ADDENDUM NO. 5

**FINAL CLOSURE CONSTRUCTION IMPROVEMENTS
AT THE COLTON SANITARY LANDFILL**

JUNE 22, 2022

FIGURE 1
IMPORT SOURCE LOCATION

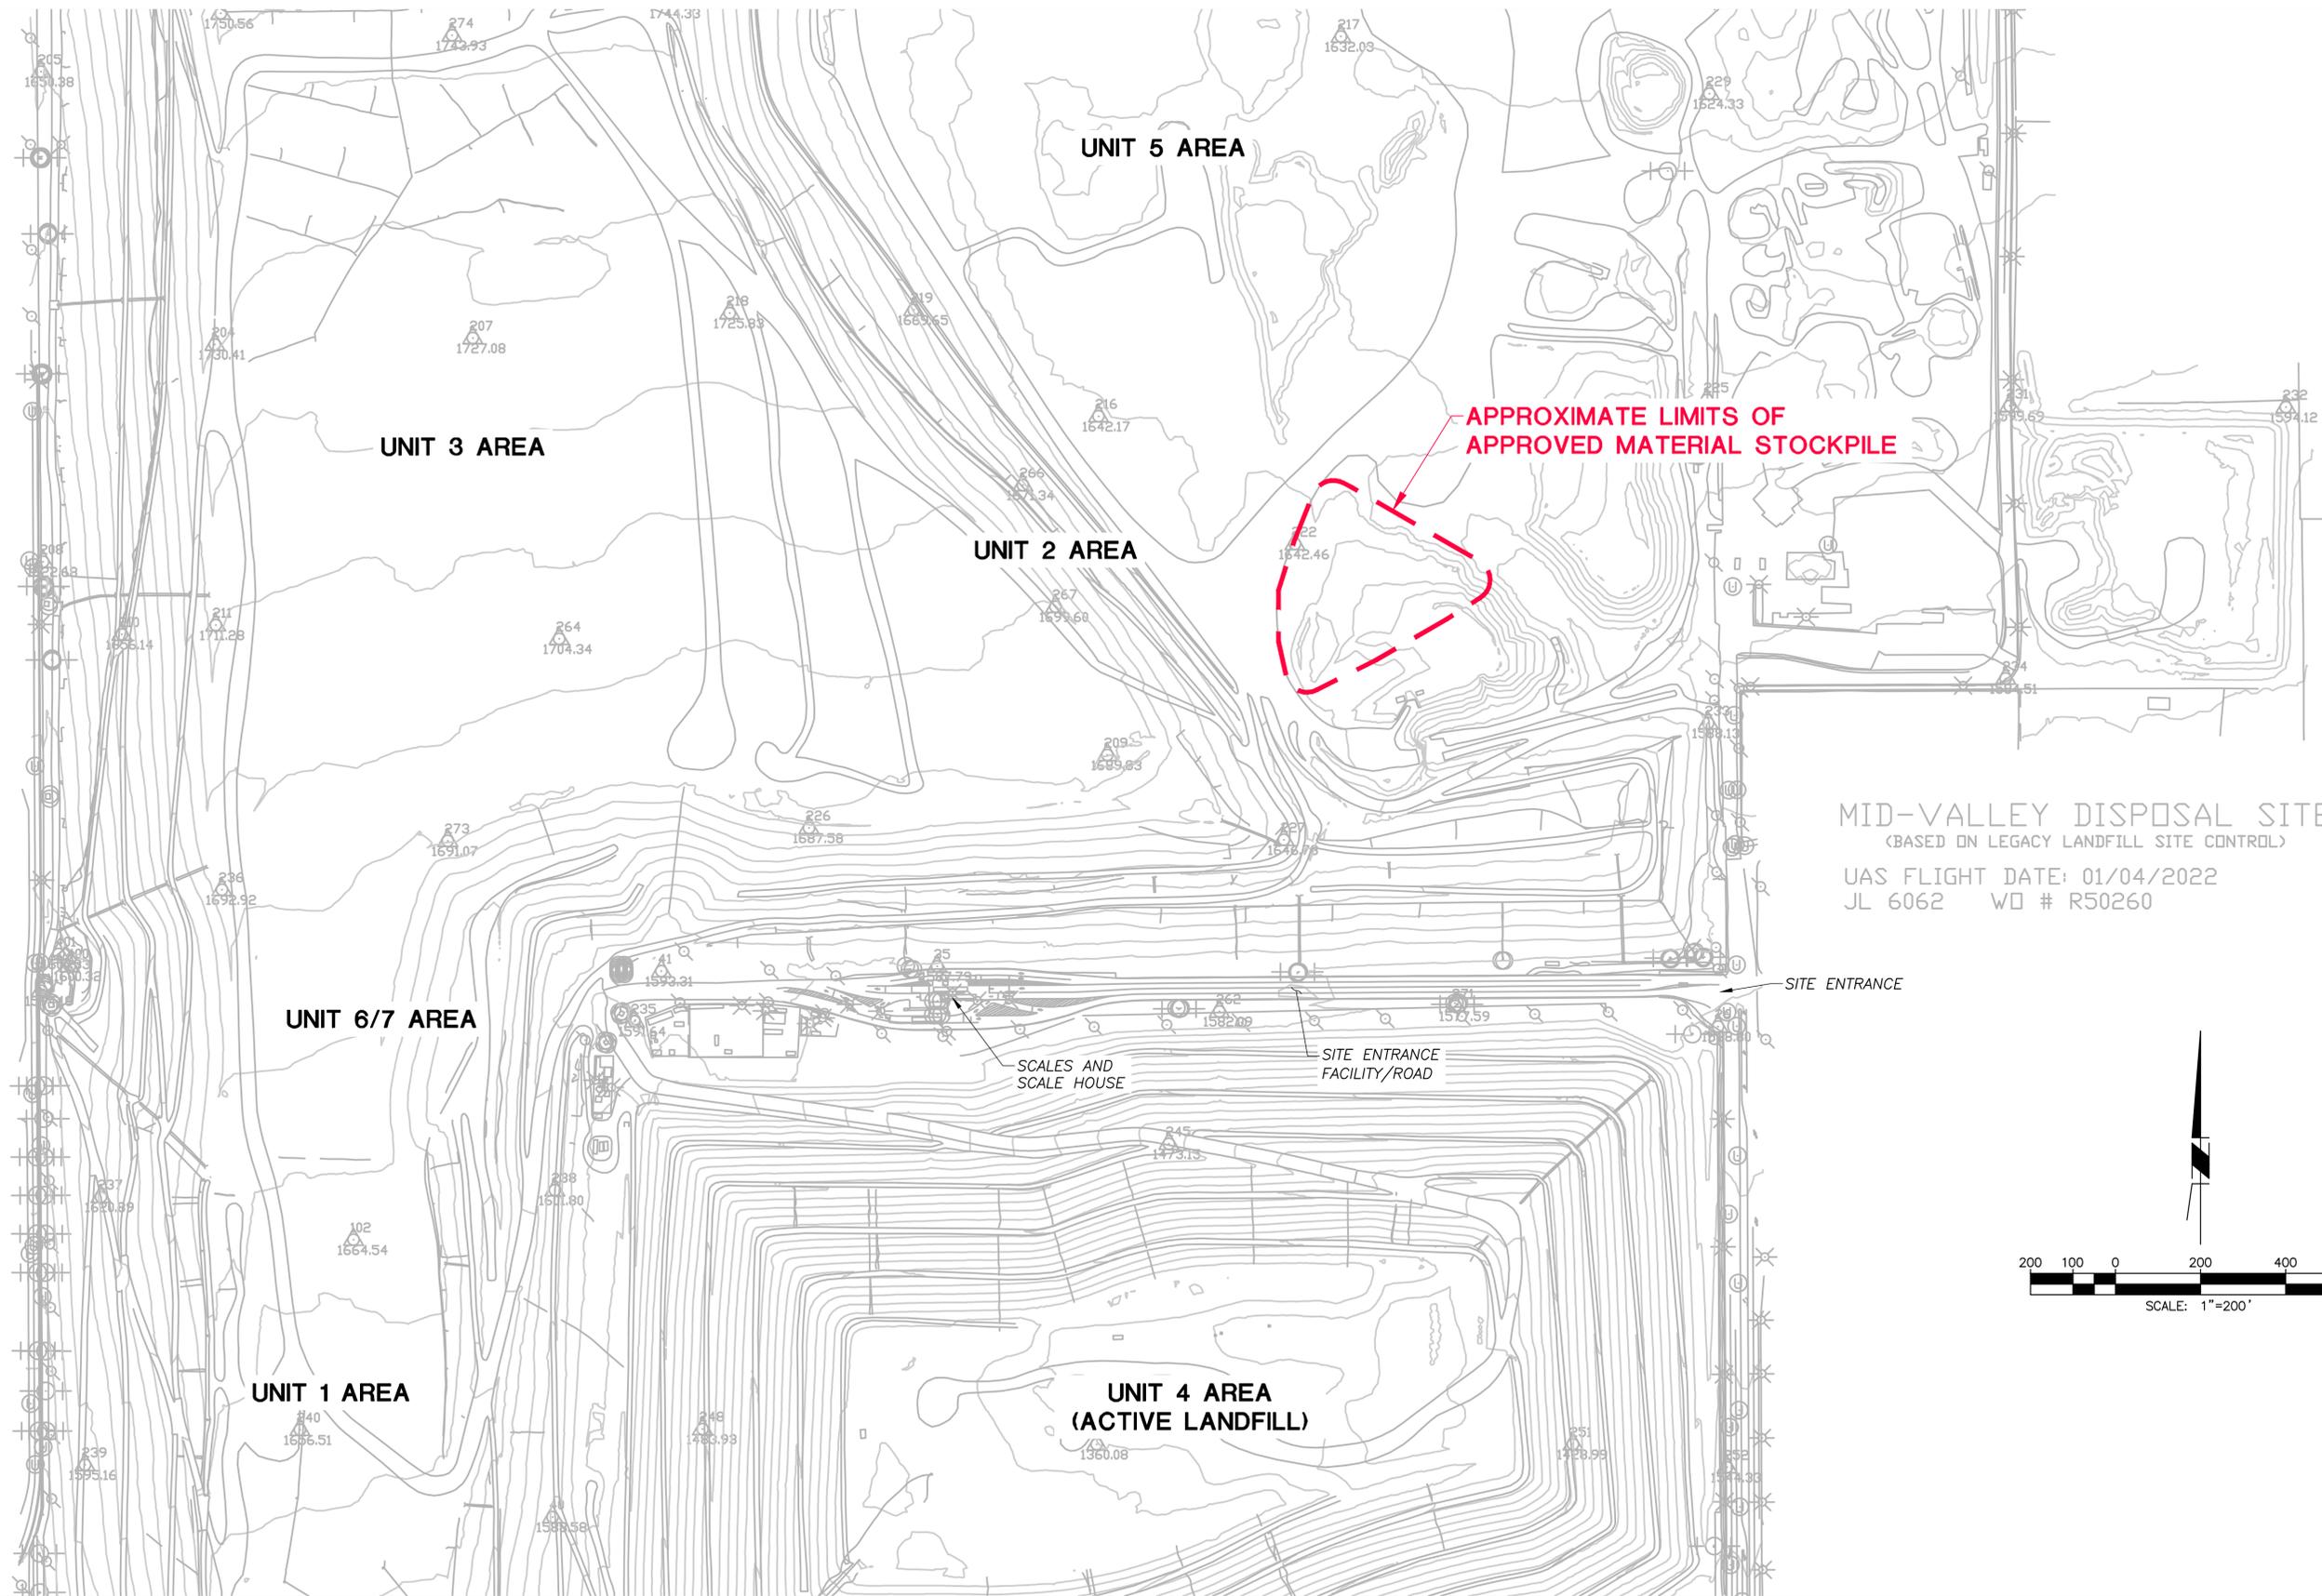
- I. A source for import material is available at the Mid-Valley Landfill. "SWMD has identified an Approved Source for Import Material (described in the Project Technical Specifications Section 2D 2.1.2) located at the San Bernardino County owned Mid-Valley Sanitary Landfill (2390 Alder Ave, Rialto, CA 92377). The Import source is approximately 12-16 miles away from the Colton Sanitary Landfill. The attached Figure 1 shows the approximate location of the material stockpile at the Mid-Valley Landfill.

There will be no cost associated with purchasing the dirt from San Bernardino County. Import/export operations at the Mid-Valley Landfill must occur during regular business hours Monday-Friday 7:00AM-5:00PM". Contractor will be responsible for loading, hauling, and screening to remove cobbles/rocks that are 4" and larger.

LITE EARTH PRESSURE RELIEF VALVE

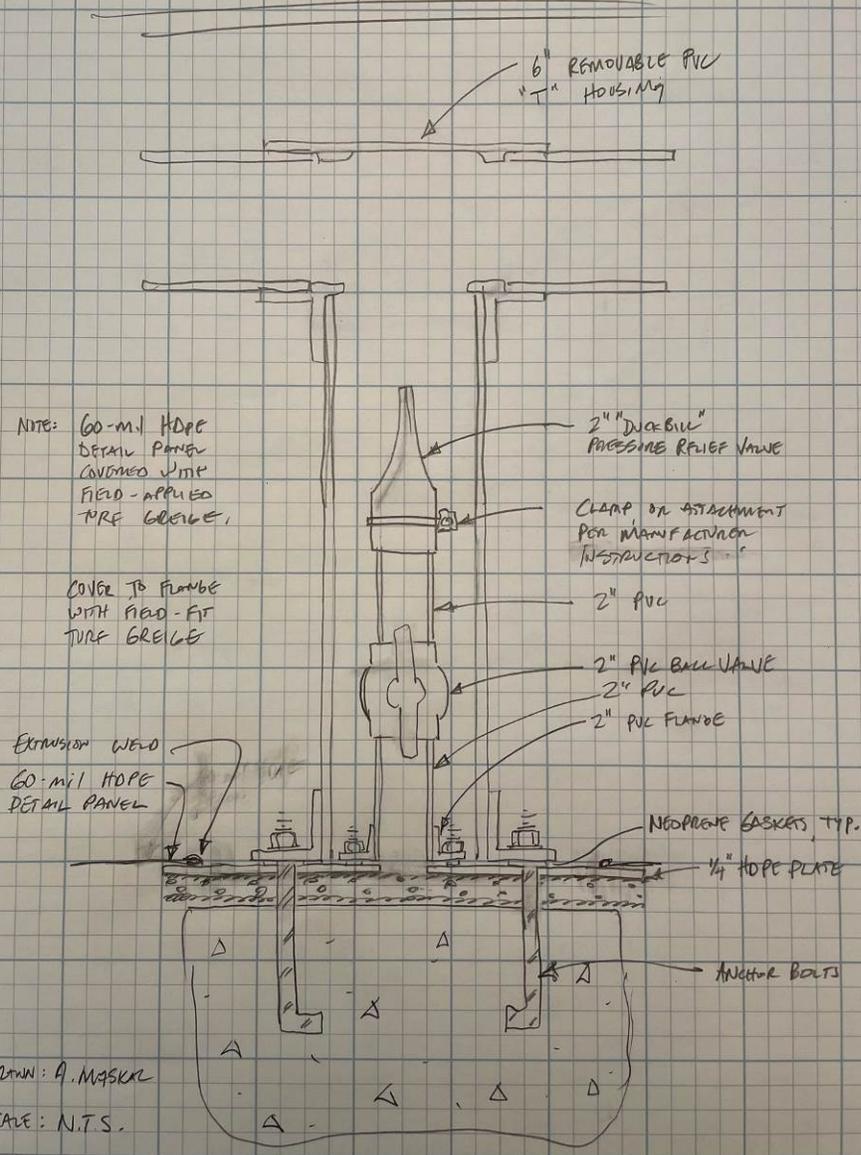
Q23. Pressure Relief Valves are proprietary to the ClosureTurf technology. Please provide the equivalent product or a design of a relief valve for the Lite-Earth system. (Ref Area: LFG Bid Item G17 – Pressure Relief Valve per Detail 6/GD14 and Section 2.1 – Passive Pressure Relief Valves)

A23. See attached LiteEarth Pressure Relief Valve Design. Alternative “B” pressure relief valves will be incidental to the Square Footage bid items for the geosynthetics – Bid Items No. 9A and 9B.

Figure 1 Site plan view, screenshot from CAD

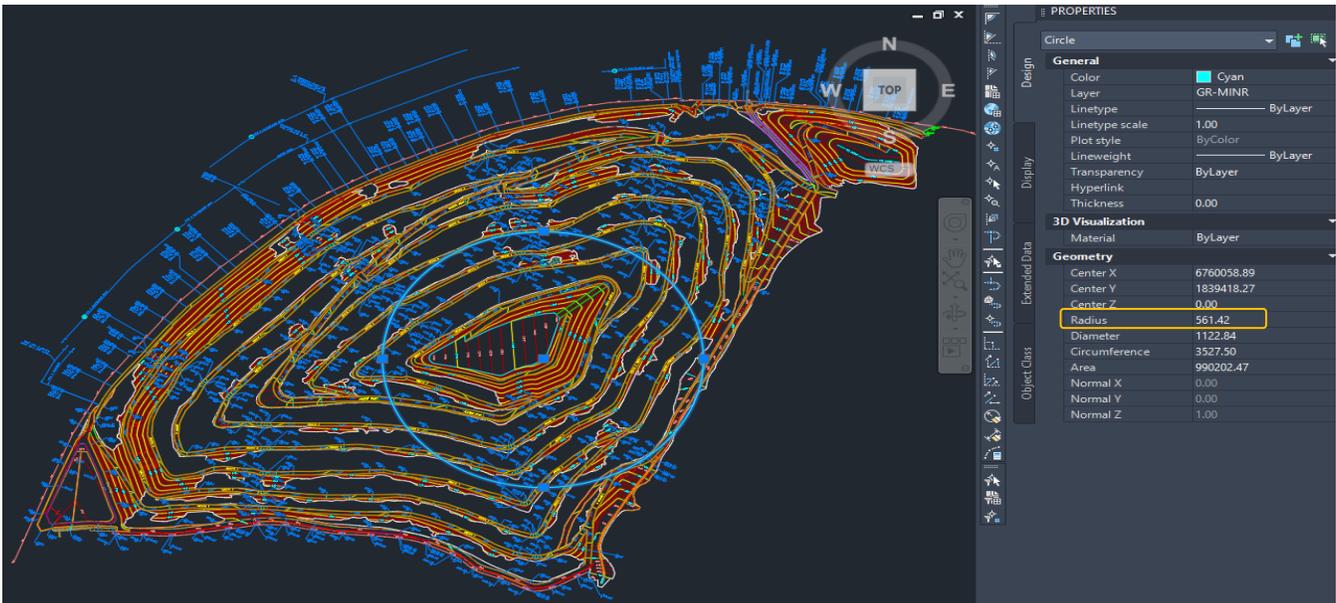
Q47. Can the engineer provide the required spacing on the Platipus Anchors required for Option B?

A47. See attached grid design for required spacing of Platipus Anchors.

$$S_{\text{h_anch}} = 9.50 \text{ ft}$$

$$S_{\text{v_anch}} = 14.50 \text{ ft}$$
